適航指令發布單

民航局AD編號 AD Number	CAA-2013-04-004C	發布日期 Date issued	2016/6/8
適用之航空產品 Applied to (models, serial numbers or part numbers, as applicable)	Kawasaki BK117 series helicopters equipped with a Goodrich rescue hoist assembly.		
主旨摘要	Equipment - Rescue Winch System - Test		
民航局 CAA <input type="checkbox"/> 本國產品 Native products <input type="checkbox"/> 其他個案 Other	設計國民航主關機構 Original Authorities <input type="checkbox"/> FAA <input type="checkbox"/> Germany LBA <input type="checkbox"/> EASA <input type="checkbox"/> CAA-NL <input type="checkbox"/> Brazil <input type="checkbox"/> UK CAA <input type="checkbox"/> Transport Canada Civil Aviation <input checked="" type="checkbox"/> Japan CAB <input type="checkbox"/> DGAC <input type="checkbox"/> CAA of Israel <input type="checkbox"/> Other _____		
	設計國AD編號 Original AD number	TCD-8201C-2016

No. TCD-8201C-2016

Airworthiness Directive

Figure 1

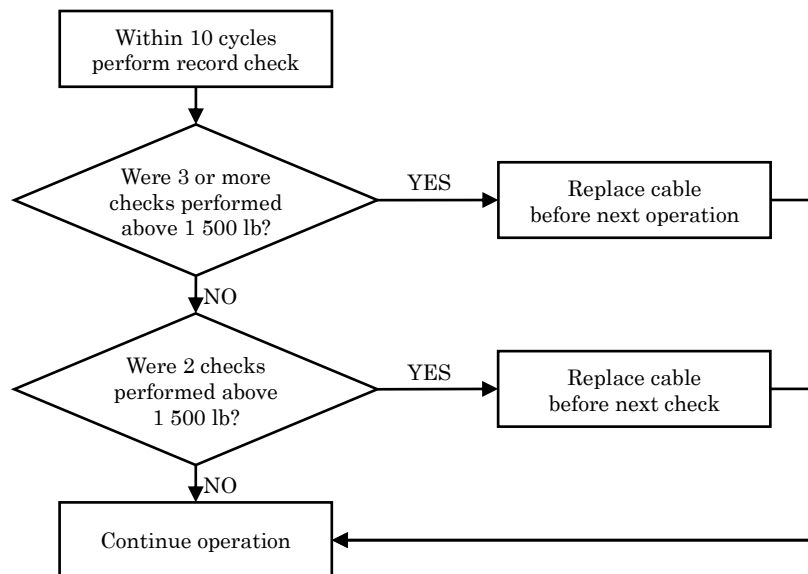
2.1 Within 10 hoist operating cycles after the effective date of this AD, accomplish a records check to determine whether, during any previous hoist load check/test, a cable was load-tested (average of 5 pulls) at 1 500 lb [680 kg] or more. If any cable is identified to have exceeded this limit during two or more hoist load checks/tests, replace the affected cable with a serviceable cable within the time interval shown in paragraph 2.1.1 or 2.1.2 of this AD. For replacement of a cable, see figure 1 of this AD.

2.1.1 If any cable is identified to have exceeded this limit during three or more hoist load checks/tests, before next hoist operation, replace the affected cable with a serviceable cable.

2.1.2 If any cable is identified to have exceeded this limit during two hoist load checks/tests, before the next hoist load check/test, replace the affected cable with a serviceable cable.
